Property Location: 506 S. Lahoma Avenue
Chautauqua Historic District

COA Request: (HD Case 15-17) Continuation of consideration of a request for a Certificate of Appropriateness for the installation of a garage, concrete paving, and a covered patio for property located at 506 S. Lahoma Avenue.

Applicant: David Boeck
922 Schulze Drive, Norman, OK 73069

A 4.1

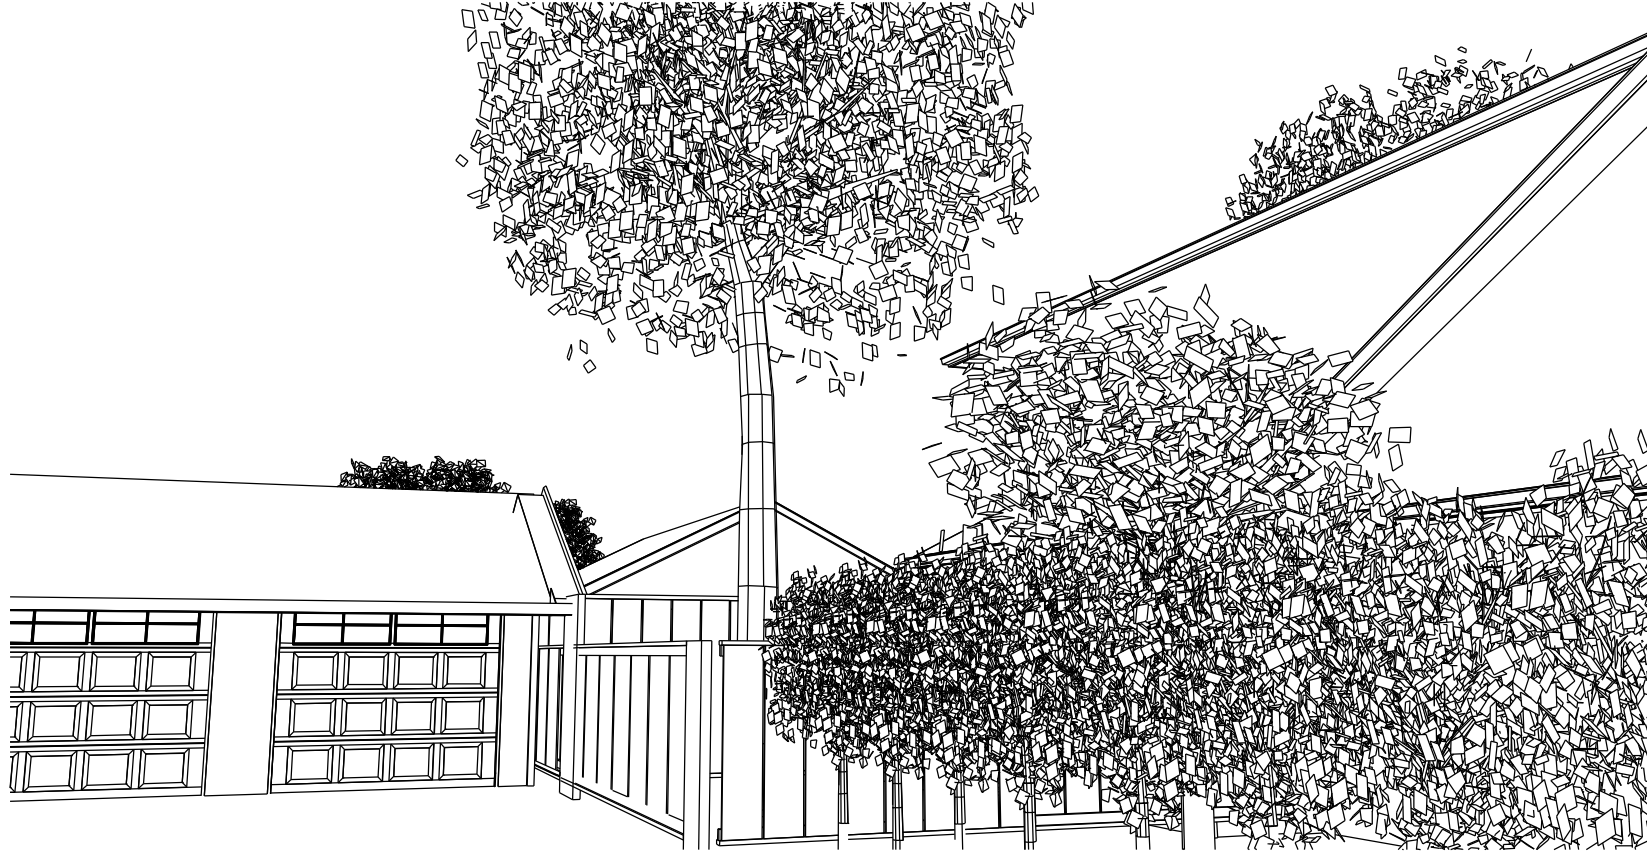
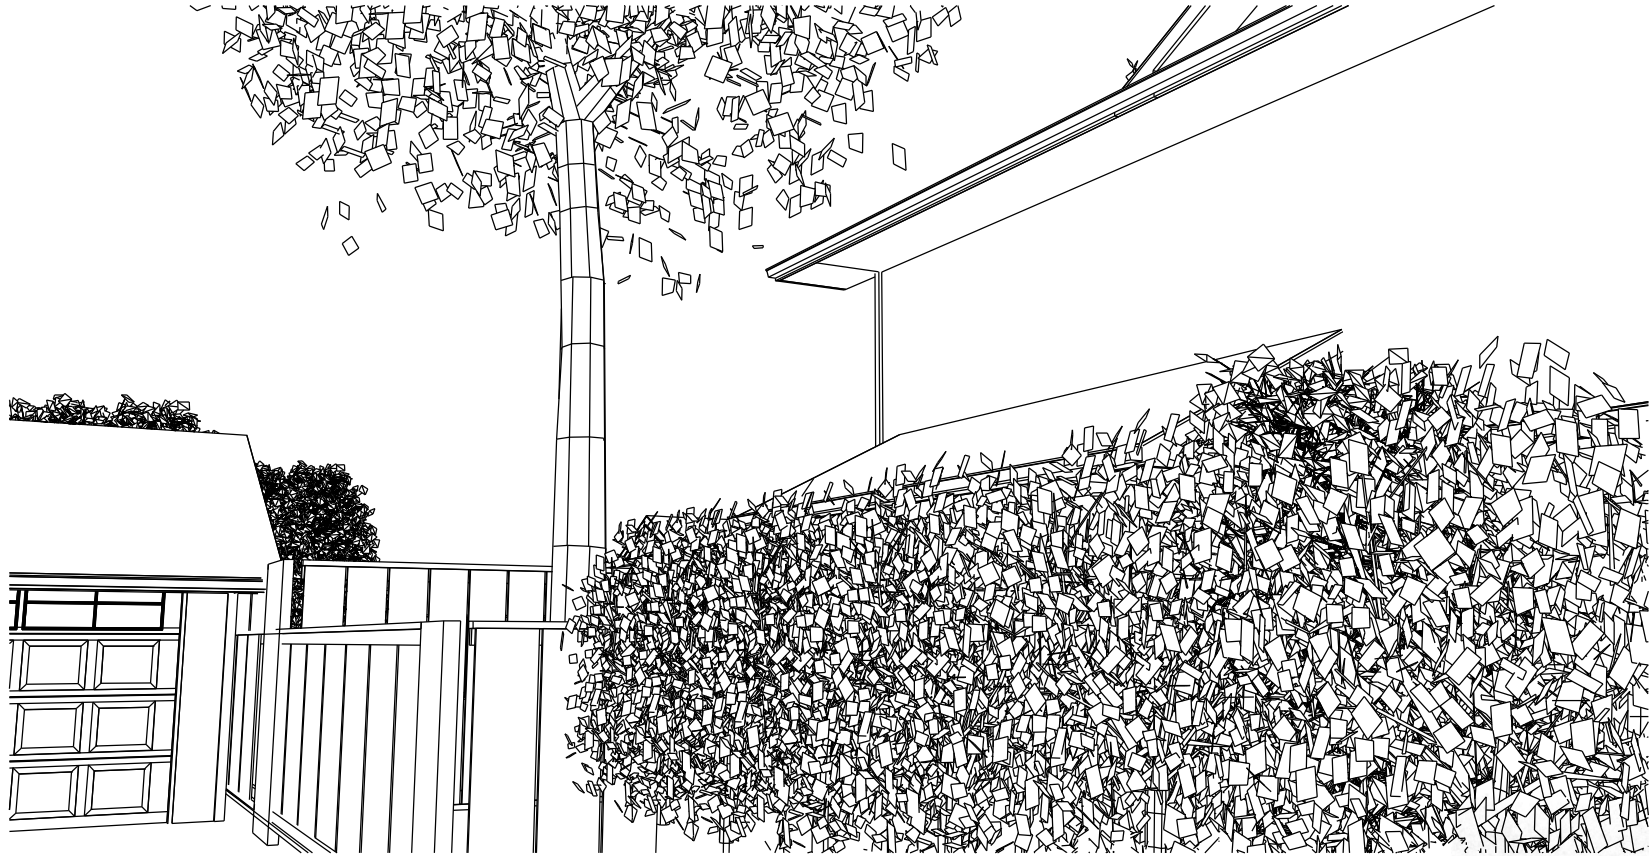
The garage as proposed in Plan 1 will be hidden for the most part by the primary structure. The proposed 8-foot connecting fence, as well as existing landscaping, will help obscure a clear view of the garage from the front of the house. The applicant has supplied renderings that illustrate the proposed garage location from two front viewpoints. According to the renderings submitted the view of the garage is limited from the street and sidewalk, but the garage can still be seen from the streetscape view.

existing conditions of the property. While this location is not the traditional location of garages in the District, the effect of the garage is minimized by being located behind the primary structure. With the installation of landscaping and an 8- foot fence, the impact of the garage from the front streetscape and from neighbors' backyards will be lessened even more. Staff finds the proposed Plan 1 location to be compatible with the **2.3.5 Guidelines for Garages** since it is placed in a practical location that works with the existing backyard elements, does not require the installation of additional pavement by utilizing the existing parking pad, and is minimally visible from the front streetscape.

Staff Recommendation: Since the garage meets the **2.3.5 Guidelines for Garages & Accessory Structures** in regards to the style, materials, size, scale and location staff recommends approval of Plan 1 for the garage.
